**PREVOST**

SAFETY RECALL

SR14-02

DATE :	FEBRUARY 2014	SECTION :	23 - Accessories
SUBJECT:	LOWER WINDSHIELD WIPER MOTOR INSPECTION

FIGURE 2: WIPER MOTOR WHICH MUST BE REPLACED. THE LETTERS "SWF" ARE STAMPER ON THE GEARBOX CASING.

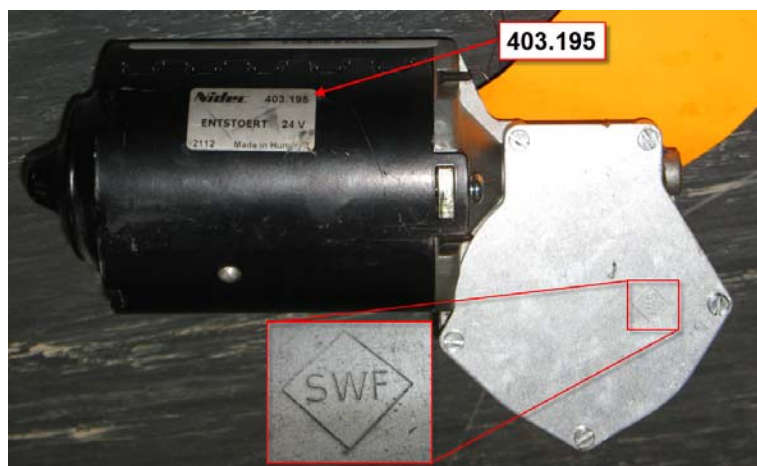
4. A wiper motor having the letters SWF stamped on the gearbox casing must be replaced. This wiper motor has also a label on which is printed the number 403 195. Proceed to the replacement of the wiper motor as described in Part 2 if the letters SWF are stamped on the gearbox casing

FIGURE 3

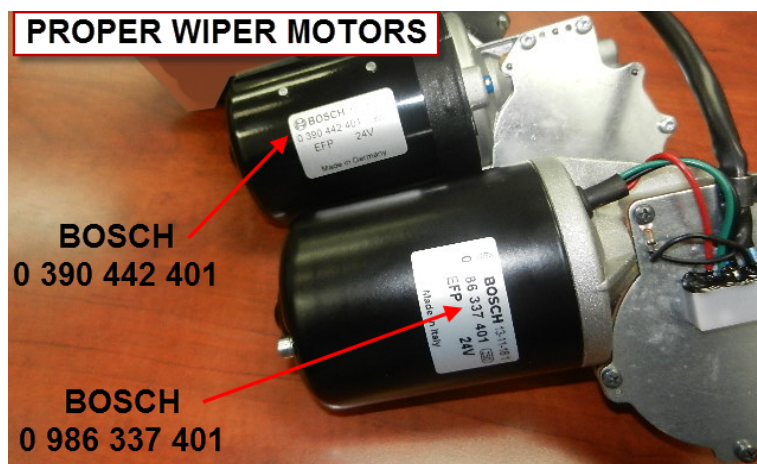
5. Proper wiper motor are identified Bosch #0 390 442 401 or #0 986 337 401. These Bosch wiper motors (Prevost part number 800328 and 800380) do not have to be replaced. If the wiper motor installed in your vehicle is one of these Bosch motors, no other verifications are required. This completes the campaign.
